Reston Master Plan Special Study: Phase II
ST09-III-UP1(B)

STAFF REPORT CLARIFICATIONS

April 22, 2015

UP5- Greater Reston **DRAFT**
Community Planning Sector
Land Use Recommendations
General Locator Map

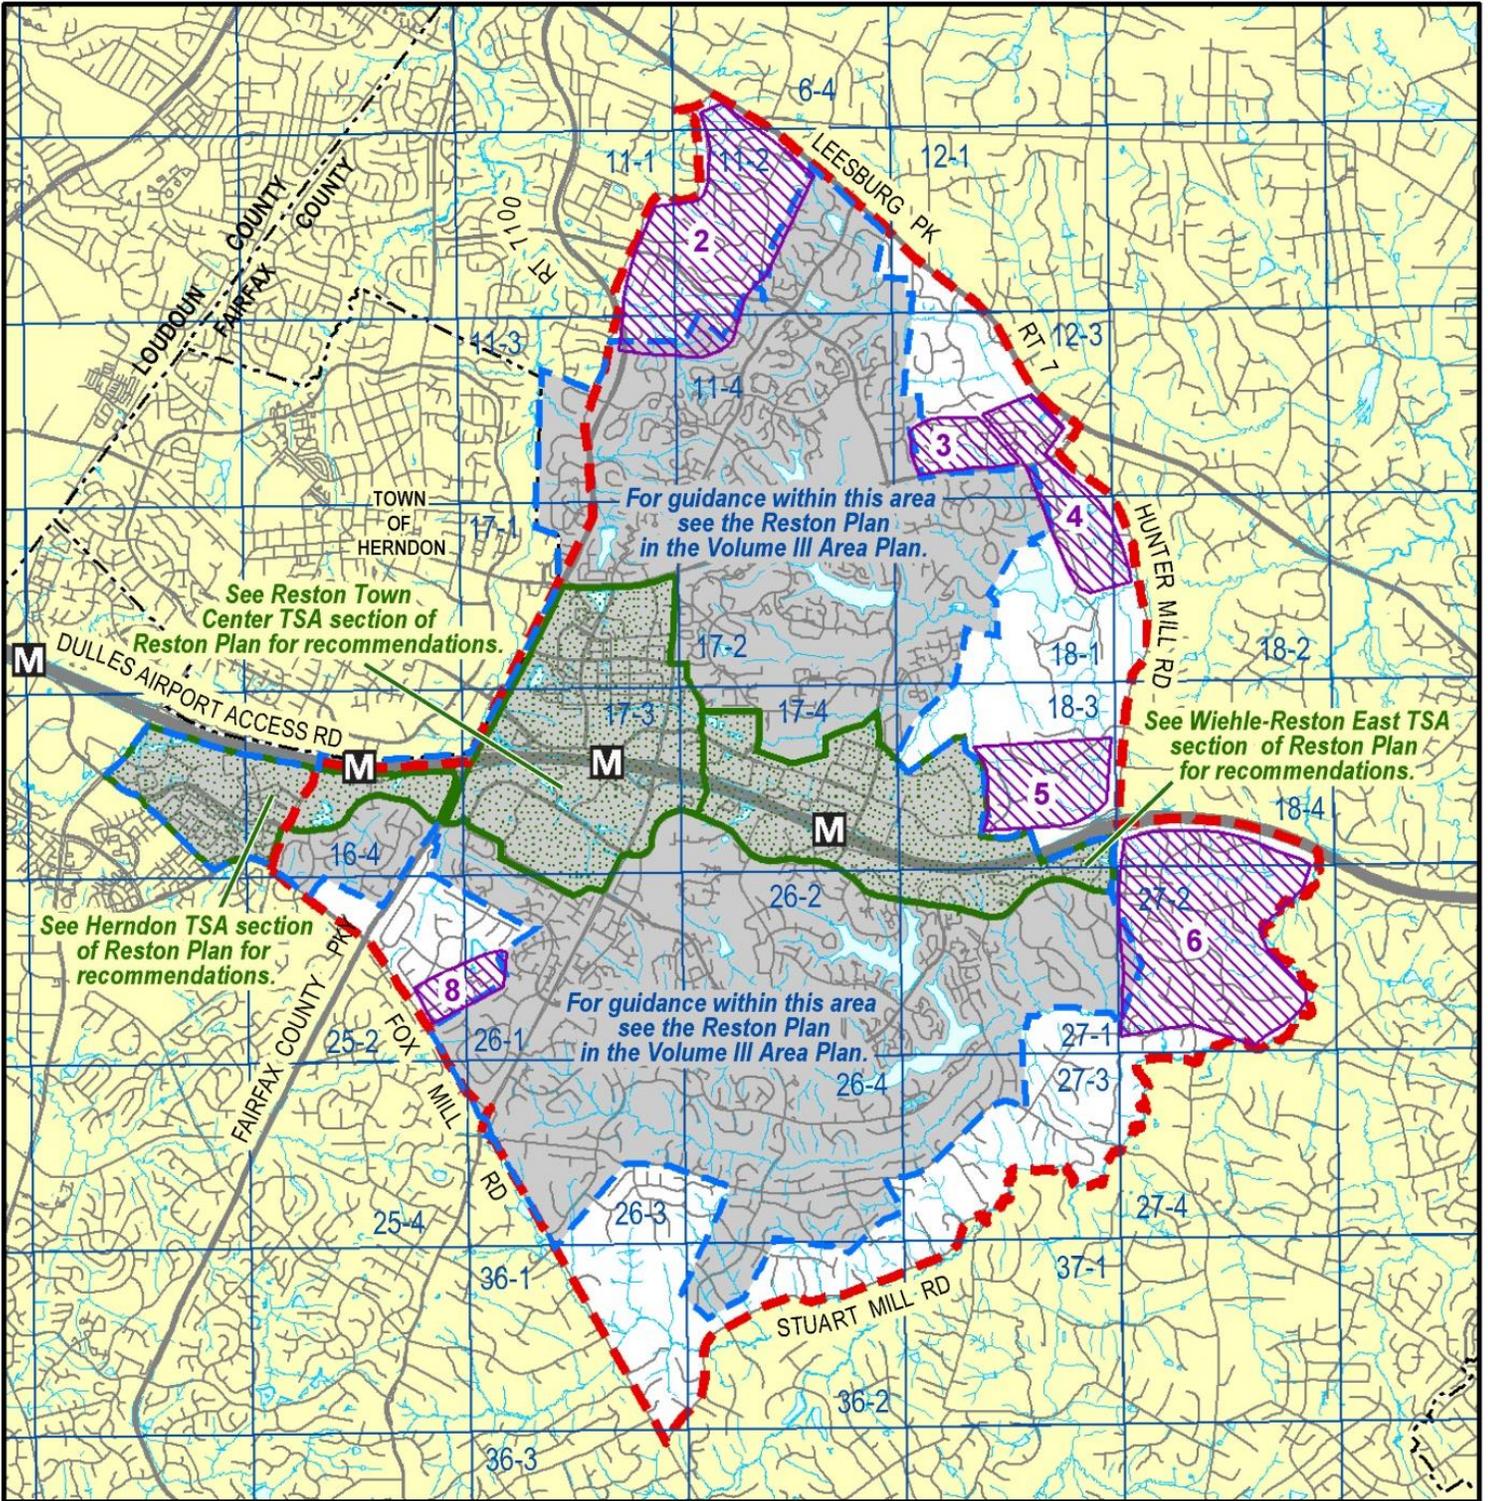
- **Page 6: Figure 66** is being modified with the figure shown below, which shows:
 - Added the outline of the Reston area;
 - Removed the Reston Plan recommendations; and
 - Renumbered the remaining UP5 Sector recommendations
